# ALERT SERVICE BULLETIN

**SUBJECT: NAVIGATION - Attitude and Heading Reference System (AHRS)****Modification of the wiring of the FLIGHT/GROUND logic  
(connector 11 ALPHA)**

Corresponds to modifications 365A084754.00 and 365A084754.01

Revision No.	Date of issue
Revision 0	2017-07-19

Figure 1

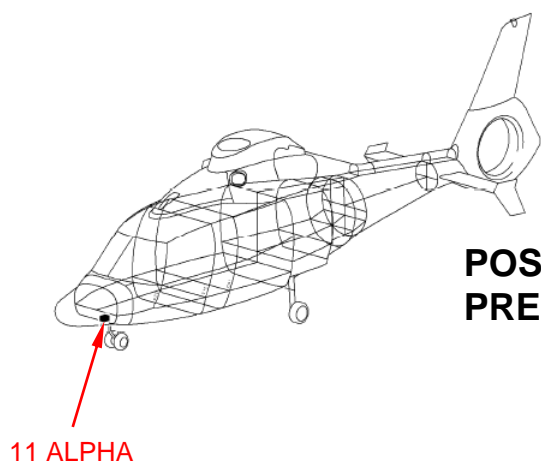
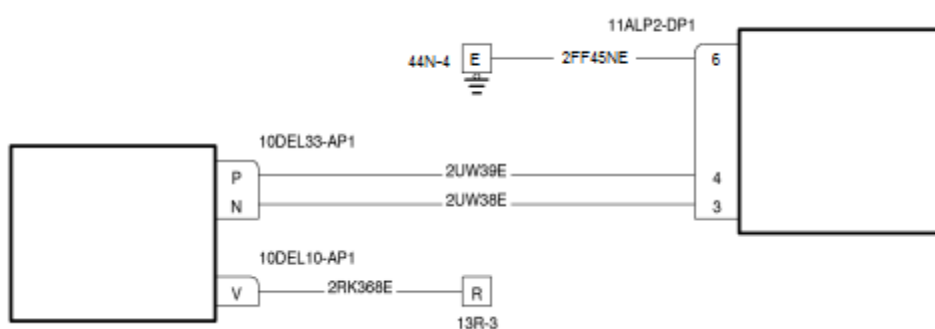
- Perform the modification of the connection to connector 11 ALPHA as per [Figure 1](#).

**PRE MOD 365A084754.00**

11ALP2-CP1	
VOL 1	1	1UW22E	
	2	1UW25NE	
	5	1FF4E	
VOL 5	6	1FF45NE	
	7	1UW28E	
VOL 7	8	1UW29E	
		11ALP2-DP1	
VOL 2	1	2UW22E	
	2	2UW25NE	
VOL 6	5	2FF4E	
	6	2FF45NE

**POST MOD 365A084754.00**

11ALP2-CP1	
VOL 5	5	1UW22E	
	6	1UW25NE	
VOL 7	7	1FF4E	
	8	1FF45NE	
VOL 1	1	1UW28E	
	2	1UW29E	
		11ALP2-DP1	
VOL 6	5	2UW22E	
	6	2UW25NE	
VOL 2	1	2FF4E	
	2	2FF45NE

Figure 2

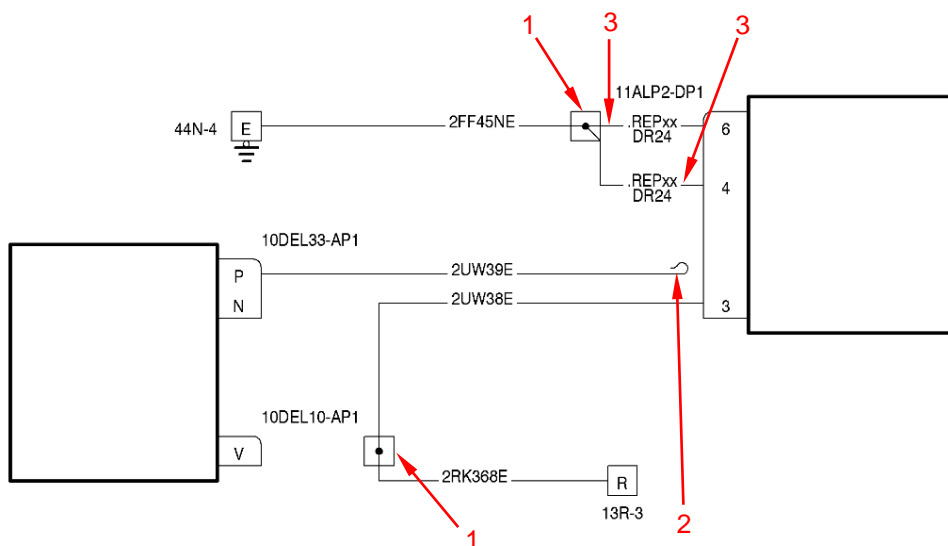
- Perform the modification of the connection to connector 11 ALPHA as per [Figure 1](#).
- Perform the modification of the wiring to connector 11 ALPHA as per [Figure 2](#).

**POST MOD 0731B89  
PRE MOD 365A084754.01**

**POST MOD 0731B89  
POST MOD 365A084754.01**
